W3F1-2019-0054

Subject: Response to U.S. Nuclear Regulatory Commission Request for Additional Information Regarding Relief Number WF3-RR-19-2, Proposed Alternative to Code Case N-666-1

Waterford Steam Electric Station, Unit 3  
NRC Docket No. 50-382  
Renewed Facility Operating License No. NPF-38

**Response to NRC Request for Additional Information**

Detail 3: Weld Overlay Design

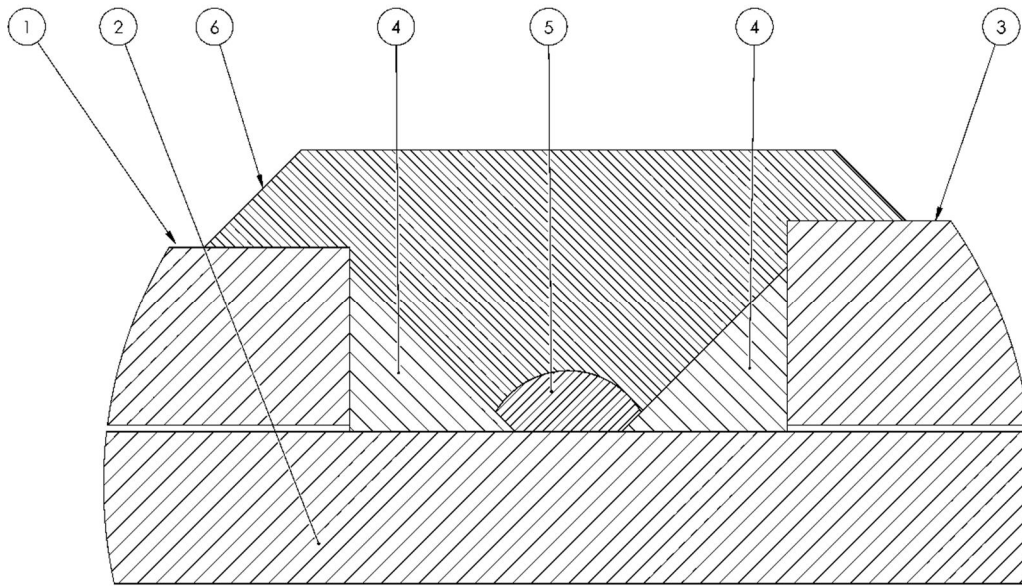
Detail 3 of the proposed alternative provides a drawing of the proposed weld overlay.

- (a) Provide dimensions of approximate thickness and longitudinal length of the weld overlay (Item No. 6 in the drawing). Specifically, provide the weld overlay thickness above the socket weld (Item No. 1 and the elbow (Item No. 3).
- (b) Provide thickness of socket weld branch connection (Item No. 1), elbow (item no. 3), and seal weld (item No, 5).
- (c) Provide the vertical length of the socket fillet weld (Item No. 4).

Approximate or estimated dimensions for these items is acceptable, if the as-built dimensions are not available.

A description of the overlay design and thickness requirements is provided, followed by answers to the specific RAI questions.

The overlay design fills in the area between the existing fillet welds from the pipe OD to the fitting socket OD, and then requires additional layers to create a uniform thickness from the elbow socket OD to the branch socket OD. The design does not take credit for the load carrying capacity of the weld metal between the pipe OD and the fitting socket OD. The structural required thickness of 0.021 inch (see RAI #6(a)) is smaller than the required thickness in Code Case N-666-1 of 0.77tnom (0.138 inch). The required thickness of the overlay at the socket connection is 0.138 inch. A minimum of two weld beads is required to achieve this thickness.

- a) The requested dimensions are given, followed by discussion of how these dimensions are determined:
  - Approximate overlay thickness at crack location= 0.387 inch
  - Approximate overlay longitudinal length = 1 inch
  - Overlay thickness above the socket = 0.138 inch minimum

Additional discussion of the overlay dimensions is provided. The OD of 1-inch NPS pipe is 1.315 inches. The OD of the elbow at the socket is assumed to be 1 13/16 inches based on vendor specification for a 3000# socket welded 90° elbow. The radial difference between the pipe OD and the elbow socket OD is approximately 0.249 inch. As stated above, no structural credit is taken for this 0.249 inch thickness. The minimum required wall thickness on the socket fitting OD is 0.138 inch. The total through thickness length of the weld repair at the crack is estimated to be 0.387 inch.

The exact longitudinal length of the overlay shall be determined in the field and is not a parameter of the design. Minimum lengths that the overlay must extend onto the fittings are specified to maintain the required design thickness in accordance with Code Case N-666-1. The estimated longitudinal length of the overlay design is approximately 0.9 inch.

b) The requested dimensions are given, followed by discussion of how these dimensions are determined:

- Socket branch connection thickness = less than 0.249 inch
- Elbow branch connection thickness = less than 0.249 inch
- Seal weld approximate thickness = 0.08 inch

As stated in response (a), the radial distance from the pipe OD to the fitting OD is approximately 0.249 inch based on a vendor specification for a 3000# socket welded 90° elbow. Exact dimensions of the fittings are not readily available. The thickness of the elbow and branch connection fitting are likely to be slightly less than 0.249 inch to allow for fit up. The nominal thickness of the seal weld is anticipated to be 0.08 inch, with some variation due to individual welder technique. Code Case N-666-1 does not allow structural credit for the seal weld. As stated above, no structural credit is taken for the 0.249 inch thickness, which includes the thickness of the seal weld.

c) The requested dimensions are given, followed by discussion of how these dimensions are determined:

- Approximate vertical length of socket fillet weld = 0.249 inch
- Socket fillet weld as-built dimensions are not readily available.

Based on the discussion in response (a), the radial distance from the pipe OD to the socket OD is approximately 0.249 inch. Pictures of the as-found condition indicate that the socket fillet weld extends to the shoulder of the fitting OD and that the weld profile is approximately 1:1. Therefore, the approximate length of each of the vertical socket fillet welds is 0.249 inch.
